# ORNL PUP-II STS Pulsed Dipole

Vladimir Kashikhin

FDR Review

April 16, 2024

# Iron Lamination Skin Depth

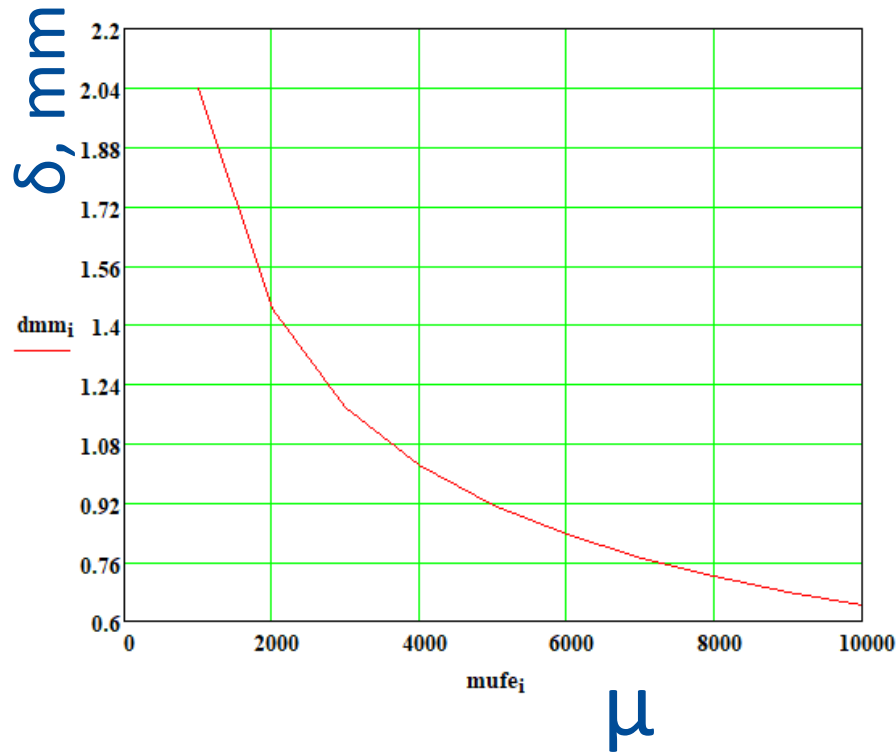
PDR recommendation:  
Evidence of skin depth in steel.

The steel skin depth is in the range of 2 mm – 0.8 mm for the magnetic permeability range of 1000 – 6000 at 28Hz. The steel thickness of 0.5 mm provides full magnetic field penetration in laminations. The steel AC losses and laminated core average magnetic permeability will be included in the design after steel properties magnetic measurements.

# Coil AC Losses

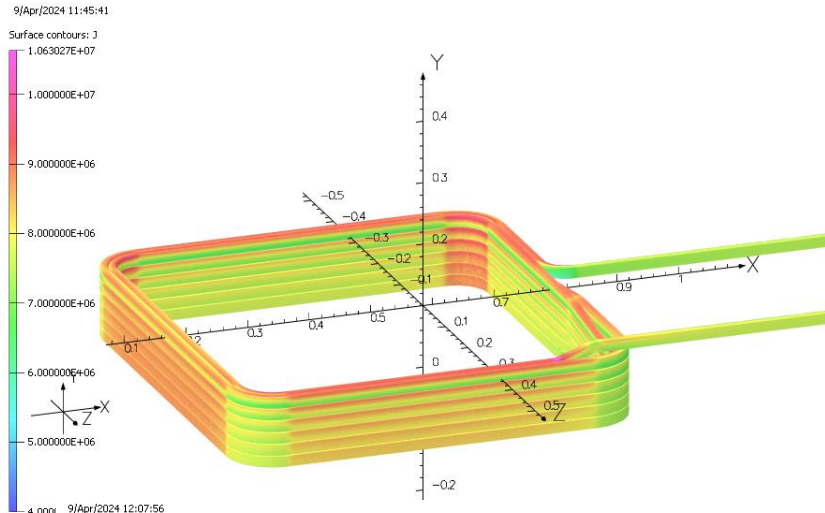
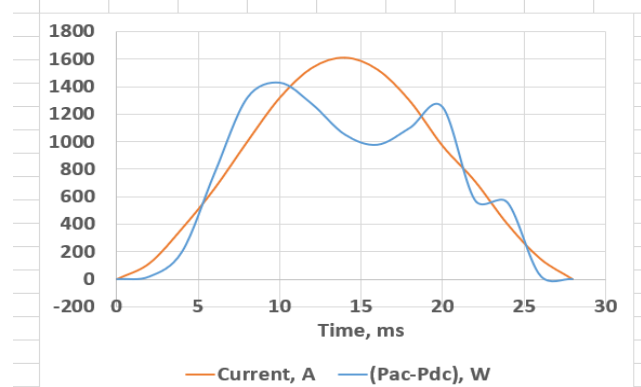
PDR Question:

Is Joule heating in the conductor included in the Opera analysis?

The magnet AC analysis showed an 8.2 % power loss increase relative to the DC case.

This effect and possible conductor area variations were included as an 11 % conductor resistivity increase.
